ACPE IWG #10

■ Pedestrian operation area proposal

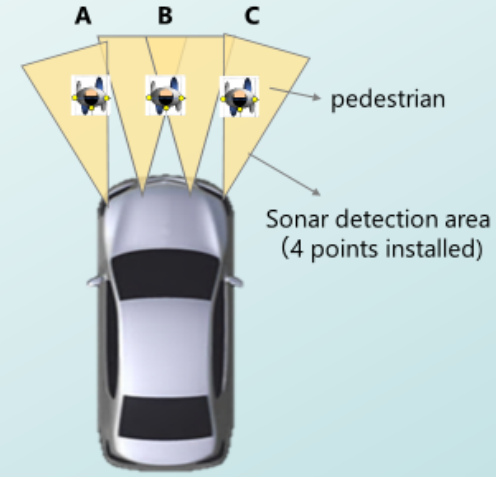
- **Detection of Sonar sensor**
 - Sonar sensor does not have lateral resolution.
 - Using two sonar sensors data, system decide it's position.
 - To avoid false positive, with sonar, objects detected by two sensors are determined to be targets. (Ensuring detection reliability)
 - Regarding objects located at the edge of the vehicle, such as A and C, detection reliability cannot be ensured with just one sensor, and it is not possible to determine whether the object should be activated.

● We can't distinguish between A and A' by one sonar detection data.

Sonar detection area (4 points installed)

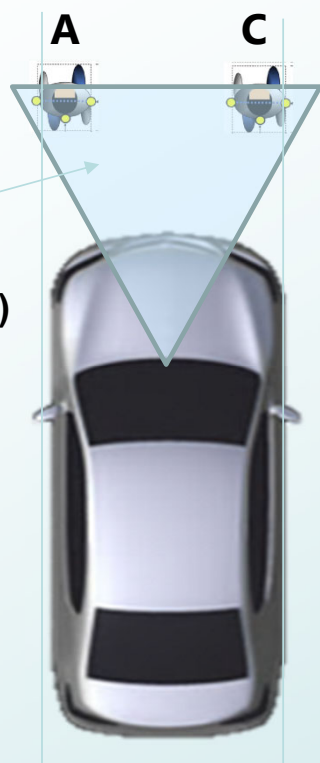
Explains that due to the detection characteristics of sonar, it is difficult to stably detect the ends of vehicles.

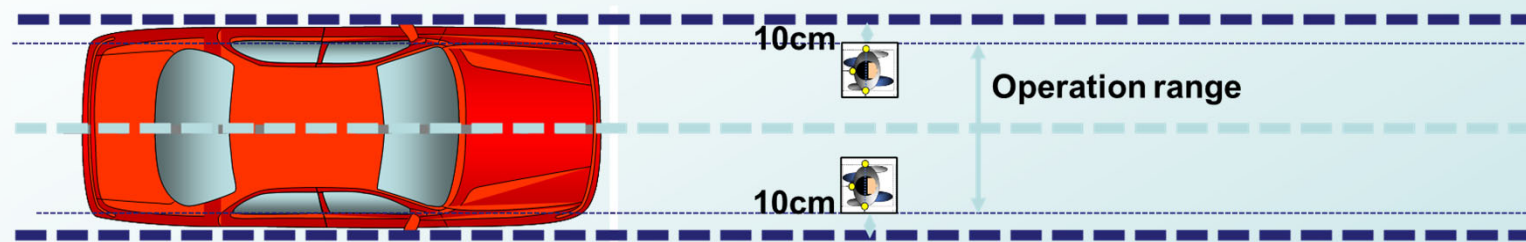
- Target ; Child pedestrian → Short height
- Detection distance :
Detection is required up to short distances
→ Only the upper chest area can be detected
→ Need to improve short-distance recognition performance
- Detection at the edge of the vehicle :
Image distortion is affected at the edges of the camera's field of view.
→ Robust detection is difficult

- Considering “False positive operation”
- Sensor detection also includes lateral position errors, and when trying to ensure operation up to the edge of the vehicle, it may detect objects on the roadside, increasing the possibility of false positive.

■ Operation area proposal

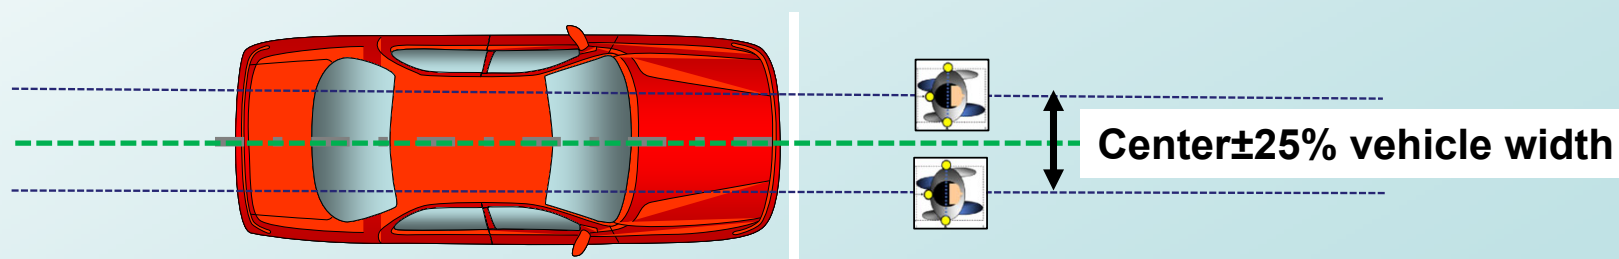
Considering the robustness of ACPE pedestrian operation, propose a vehicle center $\pm 25\%$ range.

- (iii) In the case of a pedestrian obstacle, the lateral offset between subject vehicle centreline and pedestrian centreline shall be 0.0 m and 25% of the subject vehicle width.
